**Oak Ridge Reservation (USDOE),
Clinch River & Poplar Creek Operable Units,
Oak Ridge, TN
9/23/1997**

SUBJECT: CLINCH RIVER AND POPLAR CREEK OPERABLE UNIT
RECORD OF DECISION
OAK RIDGE RESERVATION, OAK RIDGE, TN

**Record of Decision
for the Clinch River/Poplar Creek Operable Unit,
Oak Ridge, Tennessee**

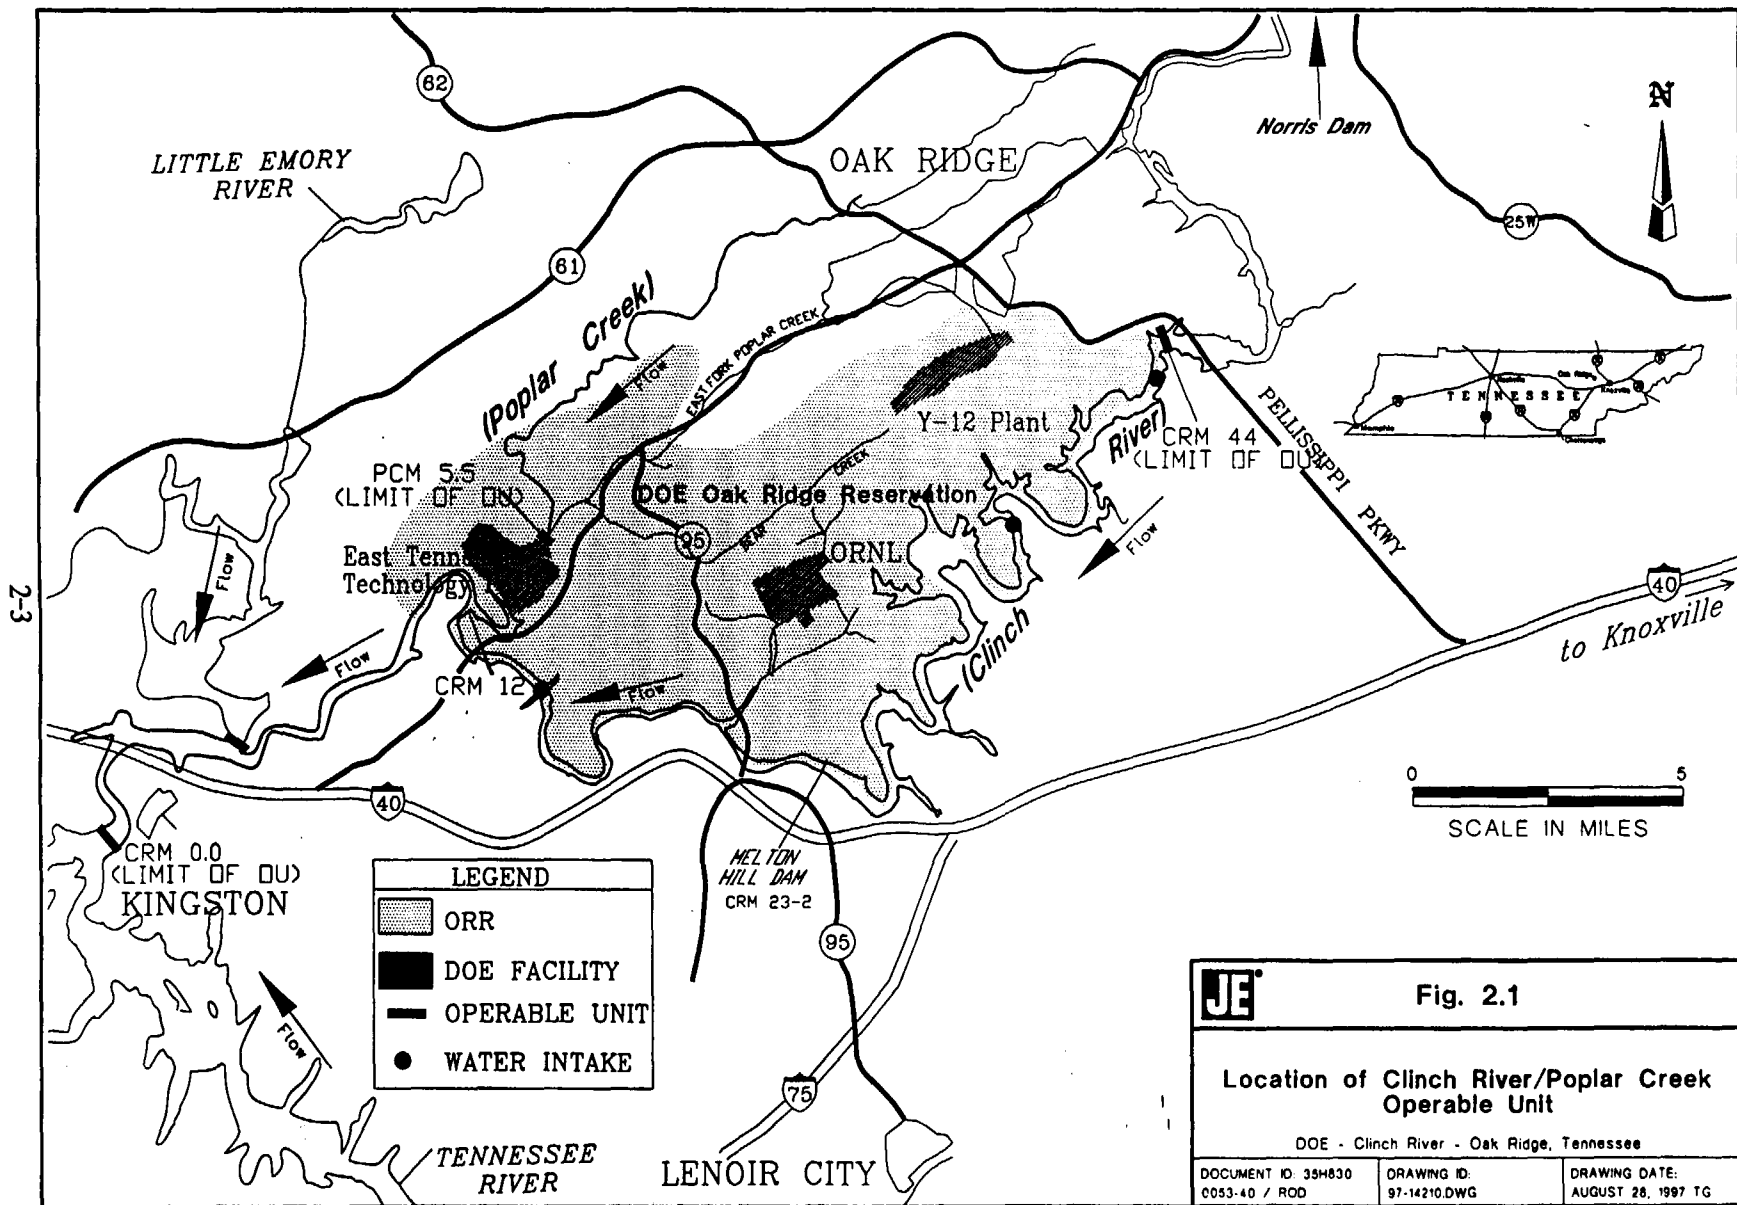
Comment: The LOC recommends adding water intakes to the site map and making the OU boundaries clearer.

Comment: The RCERB suggests adding water flow directions to the map.

Response: These items will be added to the map in the ROD.
